International  
Aero Engines

V2500 Propulsion System — Nacelle

Subject: Transmittal of Revision 1 to Service Bulletin Number V2500-NAC-71-0210

NACELLE - POWER PLANT - LINKS, FORWARD ENGINE MOUNT - REPLACEMENT OF

Engine Mount Links Change Tool Installation  
Figure 1

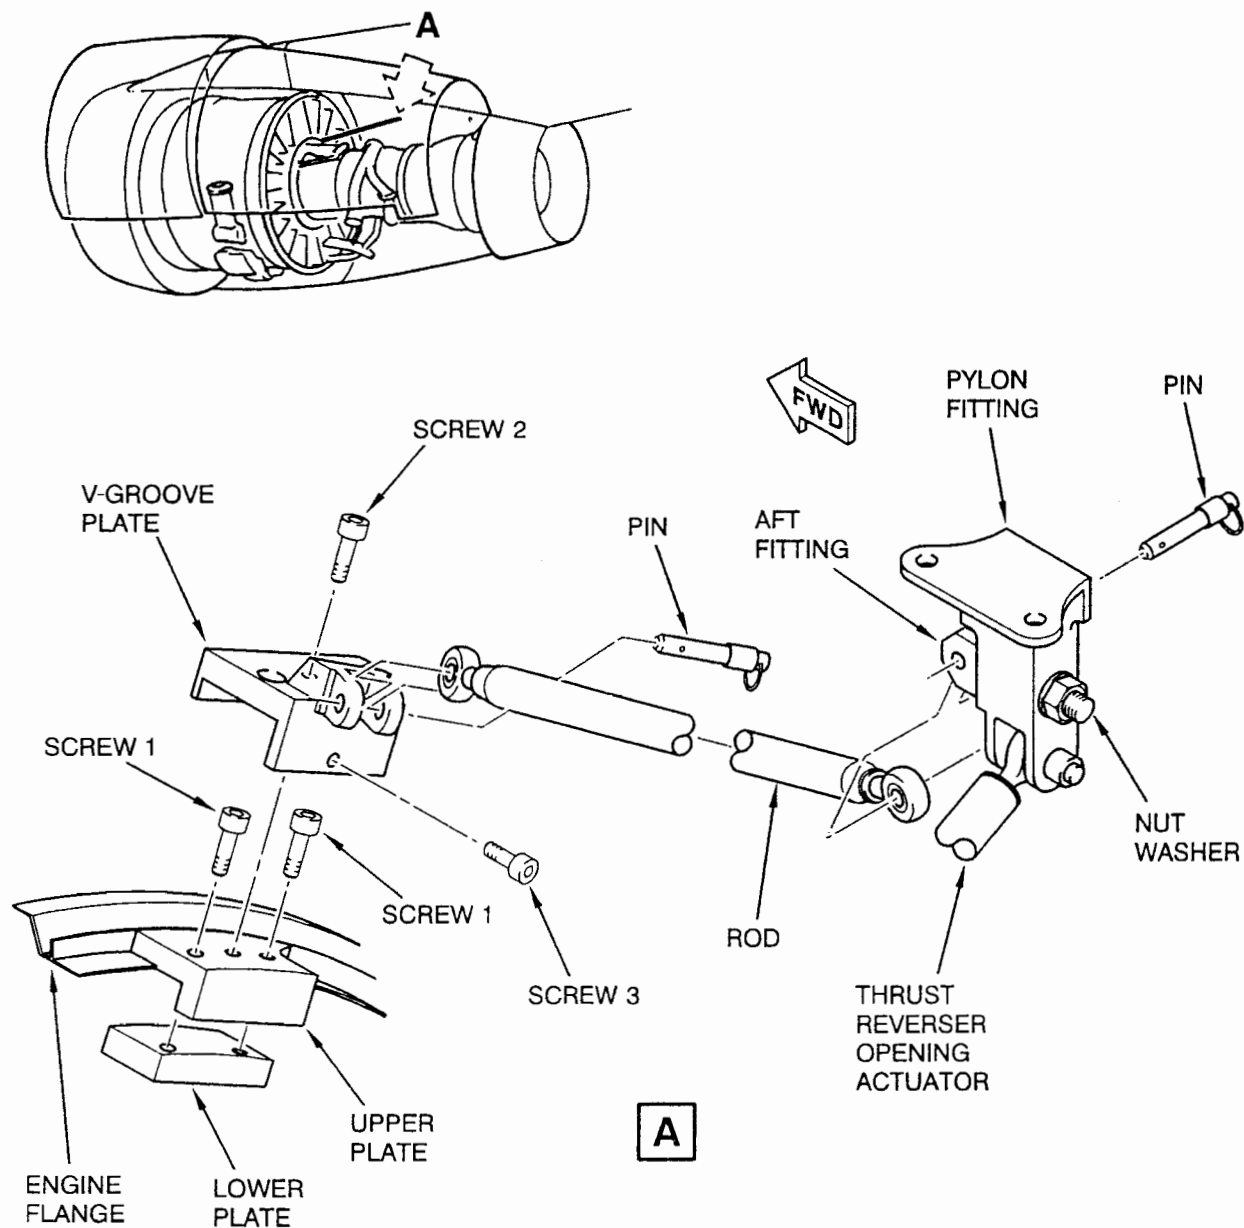
- (1) For engine mounts that are installed on the aircraft,  
install the link change tool. Refer to Figure 1.
- (a) Install the aft fitting on the pylon fitting with the  
washer and nut. Tighten the nut.
- (b) Remove the screw (2) and the v-groove plate from the  
forward fitting assembly.
- (c) Loosen the two screws (1) that hold the upper and  
lower plates together.
- (d) Put the upper and lower plates on the engine flange  
between the 12 and 1 o'clock positions (R/H side of  
the engine when you look from the rear) and finger  
tighten the screws (1).

- (e) Put the v-groove plate in the v-groove on the engine flange and finger tighten the screws (2) and (3).
  - (f) Connect the aft end of the rod to the aft fitting with the pin.

- (g) Connect the forward end of the rod to the forward fitting assembly with the pin.
  - (h) Make sure there is enough space between the rod and the pylon and engine components. Move the forward fitting assembly on the engine flange if necessary.

- (i) Tighten the screws (1), (2), and (3) on the forward fitting assembly.
  - (j) Turn the rod until the forward engine mount links can move freely and the pins (01-250) move freely in the axial direction.

- (8) For engine mounts that are installed on the aircraft, remove the link change tool.
  - (a) Turn the rod until the weight of the engine is on the forward engine mount, not the rod.

- (b) Remove the pins and the rod from the forward and aft fitting assemblies.
  - (c) Remove the nut, washer, and aft fitting from the pylon.
  - (d) Loosen the screws (2) and (3) and remove the v-groove plate from the forward fitting assembly and the engine flange v-groove.

- (e) Loosen the screws (1) and remove the upper and lower plates from the engine flange.

Replacement of Engine Mount Links  
Figure 2 (Sheet 1)

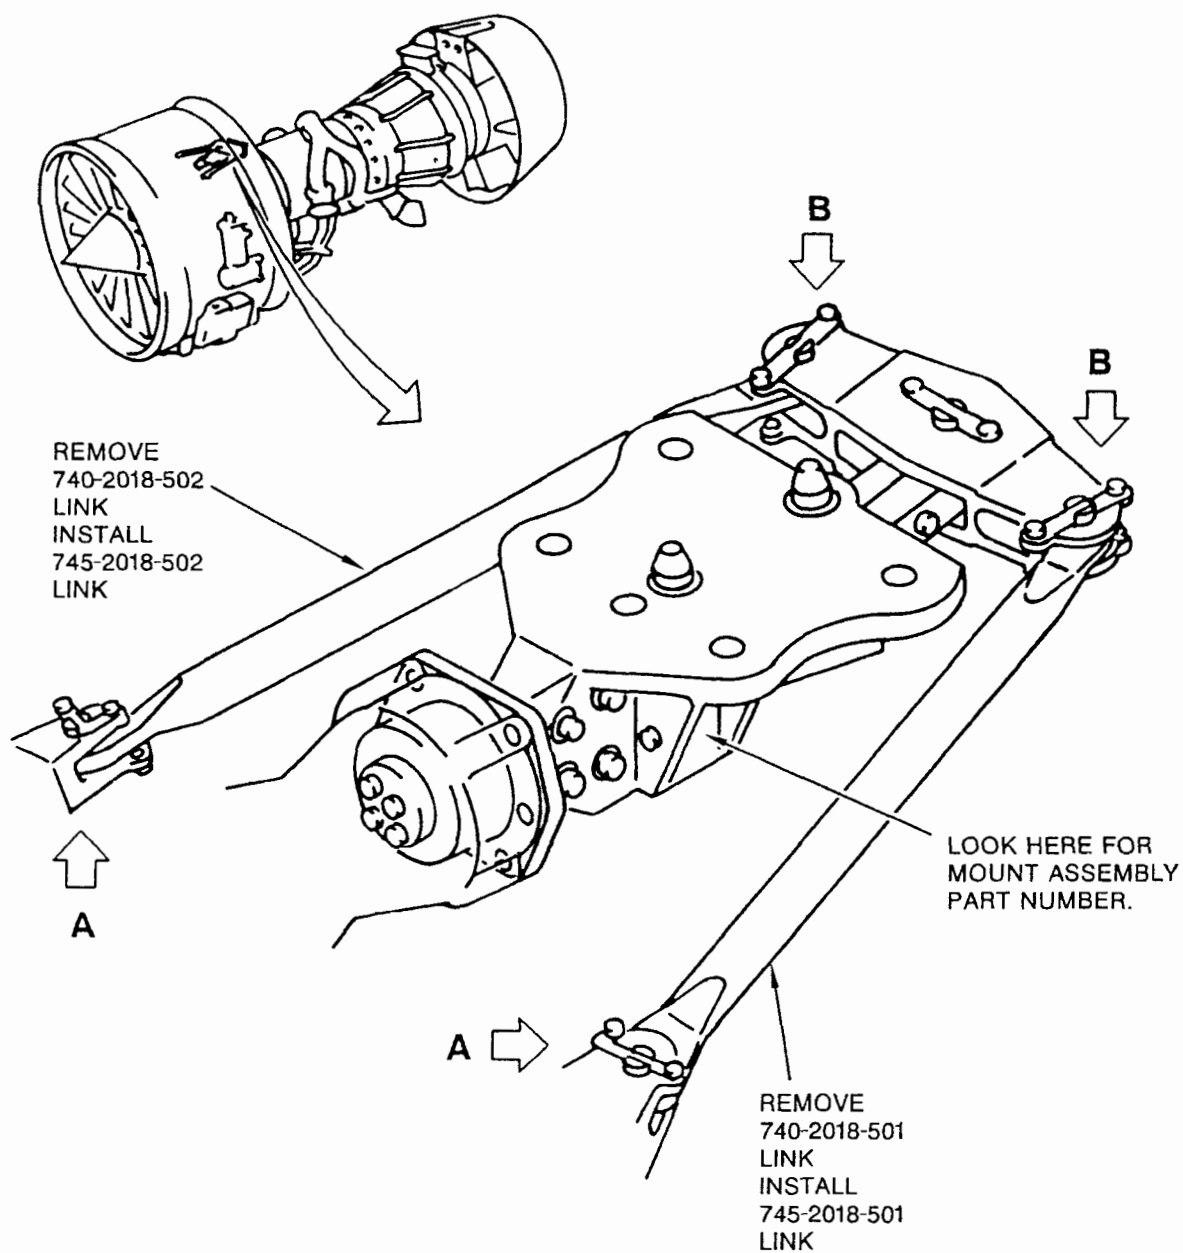
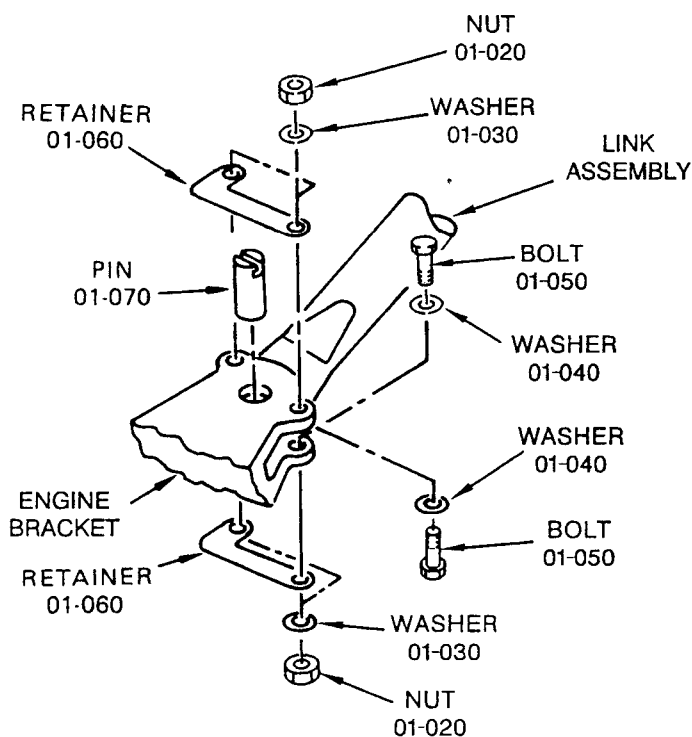
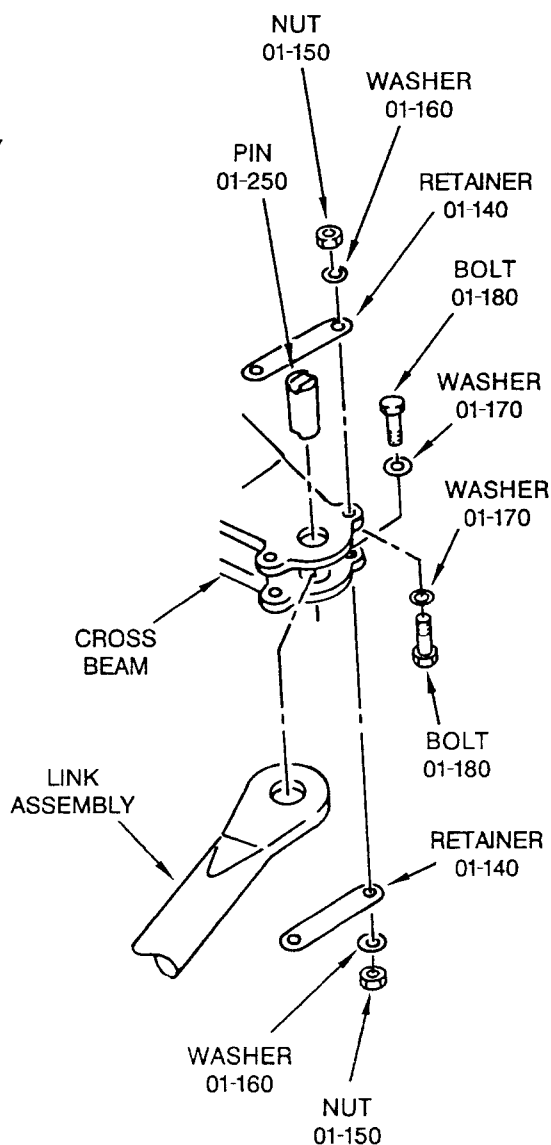
- R (1) Do IAE service bulletin V2500-NAC-71-0135.
- R (2) Inspect the forward engine mount part number. Refer to  
R Figure 2.
- R a. If the forward engine mount assembly part number is  
R 745-2010-501, do not do this service bulletin.
- R b. If the forward engine mount assembly part number is  
R not 745-2010-501, you must do this service bulletin.

- (2) For engine mounts that are installed on the engine, remove the nuts (01-020), bolts (01-050), washers (01-030 and 01-040), and retainers (01-060) from the engine bracket. Remove the pin (01-070) from the engine bracket. Refer to Figure 2.

- (3) Remove the nuts (01-150), bolts (01-180), washers (01-160 and 01-170), and retainers (01-140) from the cross beam. Remove the pin (01-250) from the cross beam. Refer to Figure 2.

- (4) Remove the 740-2018-501 (740-2018-502) link. Destroy the link. Refer to Figure 2.
  - (5) Put the 745-2018-501 (745-2018-502) link in the cross beam and the engine bracket. Refer to Figure 2.

- (6) Attach the link to the cross beam with the pin (01-250), retainers (01-140), washers (01-160 and 01-170), bolts (01-180), and nuts (01-150). Torque the nuts (01-150) to 20-25 lbin (2,26-2,82 Nm). Refer to Figure 2.

- (7) For engine mounts that are installed on the engine, attach the link to the engine bracket with the pin (01-070), retainers (01-060), washers (01-030 and 01-040), bolts (01-050), and nuts (01-020). Torque the nuts (01-020) to 20-25 lbin (2,26-2,82 Nm). Refer to Figure 2.
